Product Change Notification / JAON-18QNOS381

CCB 5014.004 Initial Notice: Qualification of a new die size (1.932x1.860mm) for Die #1 of selected Microsemi LE9653AQC, LE9653AQCT, LE9621AQC, LE9643AQC, LE9621AQCT, and LE9643AQCT catalog part numbers (CPN) available in 36L VQFN (4x6x1mm) package assembled at MMT assembly site.

PCN #: JAON-18QNOS381

CCB 5014.004
Pre and Post Change Summary
PCN#: JAON-18QNOS381

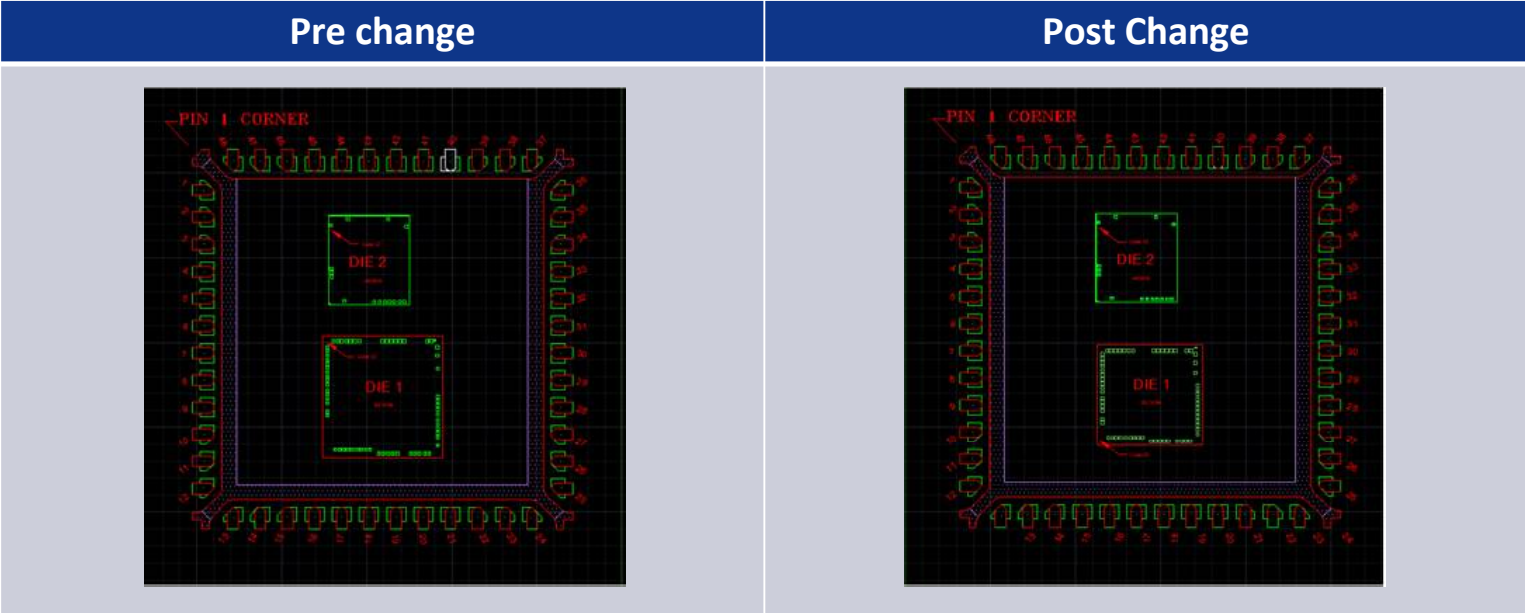
Pre and post change comparison
